S E R V I C E B U L L E T I N

FUJI HEAVY INDUSTRIES

NO. FAS-013

1. SUBJECT : Adjustment for balanced fuel flow from right and left fuel tanks.
2. AIRCRAFT AFFECTED: All FA-200 Serial No. 1 through 101 airplane.
3. PRIORITY : Essential.
4. REASON : In order to clarify the method of adjustment for balanced fuel flow from right and left tanks.
5. DESCRIPTION : Adjust the fuel tank vent tube so that the difference between the indications of left and right fuel quantity indicators should never exceed "1/2". Work procedure is mentioned in paragraph 13.
6. ACCOMPLISHMENT : Anytime when the difference between the indications of left and right fuel quantity indicators exceeds "1/4" or the difference between the levels of fuel in the left and right fuel tanks exceeds 2 inch.
7. APPROVAL : JCAB approval No. 317.
8. PARTS REQUIRED : Nothing.
9. SPECIAL TOOLS : Nothing.
10. WEIGHT AND BALANCE: No change.
11. RECERENCE : Nothing.
12. MANPOWER : Little.

13. WORK PROCEDURE :

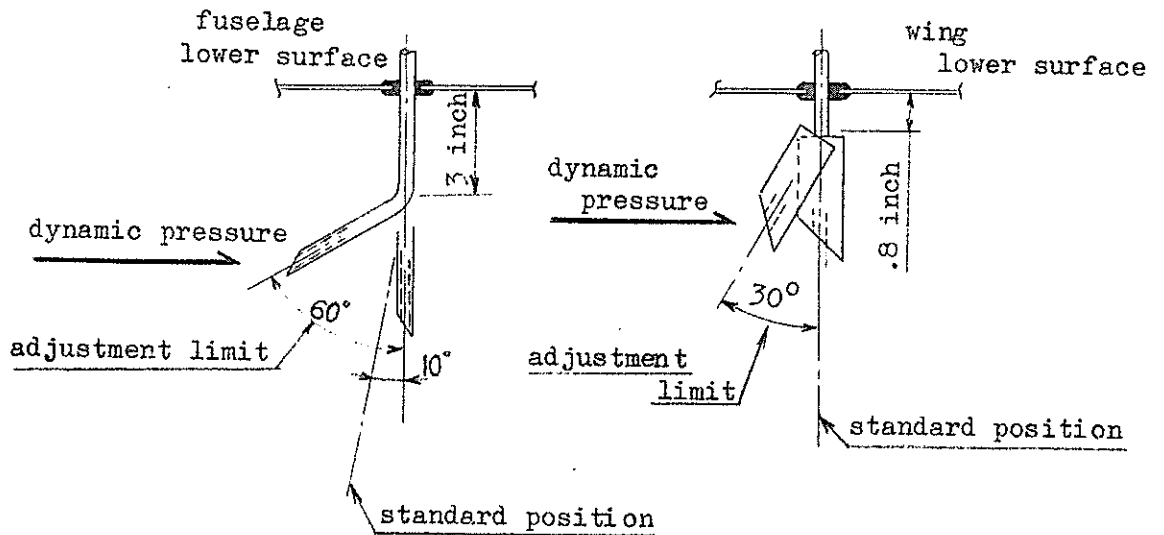
Bend forward the vent tube of the tank of which the fuel consumption is less than another tank, in order to obtain more dynamic pressure.

Tube bending angle should be within 0 - 60 degree for the Serial No. 1 - 55 airplanes, or within 0 - 30 degree for the Serial No. 56 and on airplanes. Never exceed these angles.

- Note 1) The cut end of vent inlet should be directed forward.
- 2) Don't bend the vent tube of the tank of which the fuel consumption is more.
- 3) Never bend the sump tank vent.

13-1 Adjustment limit of air-vent tube.

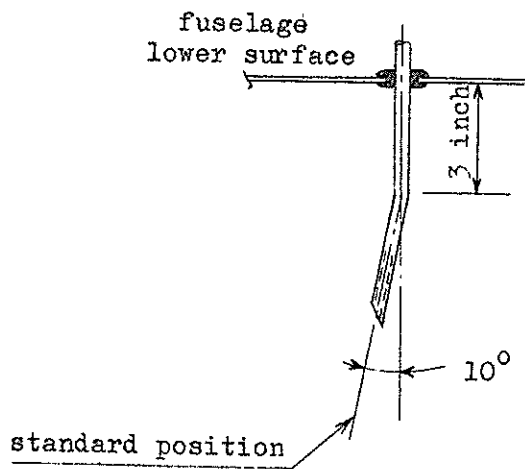
(1) Vent tube of wing fuel tank.

S/N 1 - 55 airplane

S/N 56 - 101 airplane

(2) Sump tank vent.
